TECHNICAL INFORMATION

Resistor Installation Needed for DRL Activation

No: 86/09/99/NAS Ref: Issue: 1 Date: 11/12/99

DISCOVERY Series II (LT)

XBL100200.....DRL Resistor

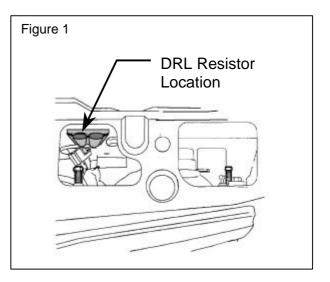
The DRL resistor has been deleted from the US build specification in the 2000 models. When the DRL feature is activated as a customer option on Discovery Series II vehicles without the resistor, the headlights will flicker in DRL mode, but not when the headlamp switch is turned on. In addition, a buzzing noise may be heard in DRL mode.

VERIFY THE RESISTOR IS INSTALLED WHEN DRL FEATURE IS TO BE ACTIVATED.

The DRL resistor is available as a separate part. Installation of this resistor on vehicles produced after the production change is necessary for proper DRL operation.

- 1. Verify that vehicle is equipped with the DRL resistor.
- 2. If the vehicle is not equipped with the DRL resistor, refer to the WSM and perform the following:
 - Remove LH headlight and top cover panel to access wiring.
 - Disconnect and discard wire jumper at connector C0653.
 - Install DRL resistor on rear vertical headlamp splash protection body panel. (Figure 1)
 - Connect wiring to resistor.
 - Install headlamp and top cover.
- 3. Follow the TestBook procedure and activate DRL mode.
